| Flight Procedures Cover Page          | Task Action:<br>P-NOTAM | Task Type:<br>IAP              | Estimated Chart Date:<br>07/09/2026 | APWS Task ID:<br>292E1332133B46DDADE7B0B768A9920C | APWS Project ID:<br>03052FEF6F8E498784149908D2FD6A4E |
| Procedure:<br>RNAV (GPS) RWY 6 ORIG-B |                         | Enroute:<br>NO                 | Specialist:<br>Johnson, Timothy     |   | Agreement Number:                                    |
| Airport ID:<br>KCDN                   |                         |                                | Airport City:<br>CAMDEN             |   | State:<br>SC   |

# RNAV (GPS) RWY 6

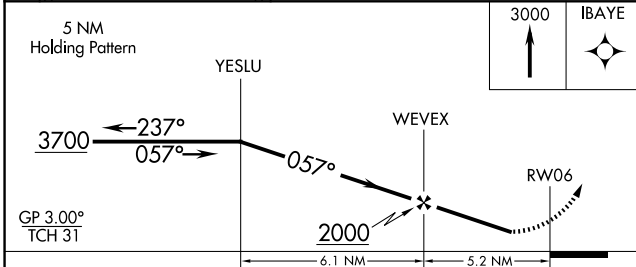
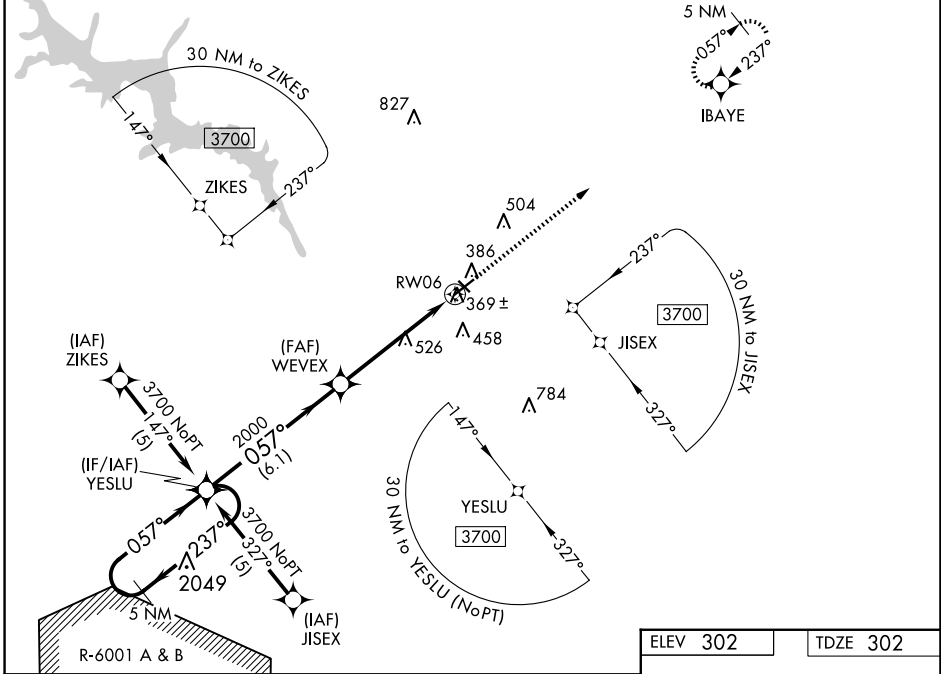
Visibility Initiative (Garmin) - Update IAP visibility minimums IAW Order 8260.3, Chapter 3, Section 3-3. Visibility Minimums.
